2AM-WTP1830 Design Report GSP-2 Storage Pond – Clarifications

Date: January 22nd, 2026

Figure 3 – Average Whale Tail Yearly Cumulative Precipitation

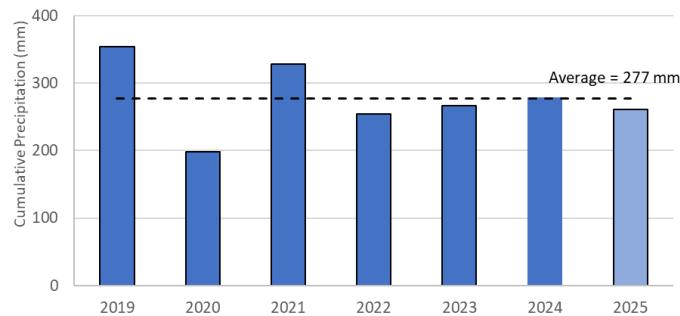
Agnico Eagle collects precipitation data at both the Meadowbank and Whale Tail sites. Historic precipitation data at the Whale Tail site since 2019 is shown in Figure 1. Estimated climate information included in the Whale Tail Mine Water Management Plan (2025) and provided by SNC (2015) is shown in Table 3. For the purposes of this evaluation, Agnico Eagle used the higher value of measured average yearly cumulative precipitation of 277 mm, compared to the lower estimated climate average of 249 mm, while ignoring evaporation and sublimation loss to increase conservatism.

Figure 4 – Catchment Area Plan View

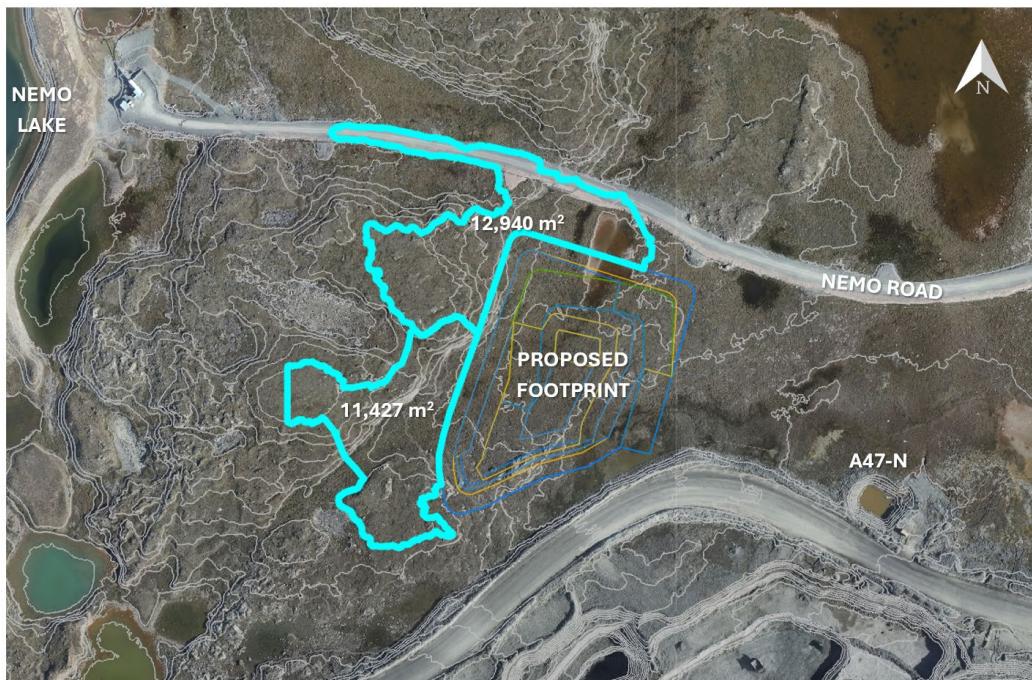
The catchment area upstream of the proposed GSP-2 area was evaluated using AutoCAD Civil3D and the most recent site topographic survey from August 2025. There is a natural ridge directly northwest of the project area, which minimizes the catchment area and separates the project area from the Nemo Lake watershed. The two contributing sub-catchments areas of 12,940 m² and 11,427 m² are shown in Figure 2, and cumulate to a total catchment area of 24,367 m², or approximately 25,000 m². All runoff southeast of the proposed footprint naturally flows towards the existing A47-N sump.

The saline water stored in GSP-2 is planned to be returned underground at the end of the life of mine. Assuming this will be completed within 2 years, this provides a 5 year life span for the structure (2026-2030). Assuming 277 mm of annual precipitation across an area of 25,000 m², an additional volume of 34,625 m³ is required, alternatively presented as approximately 35,000 m³.
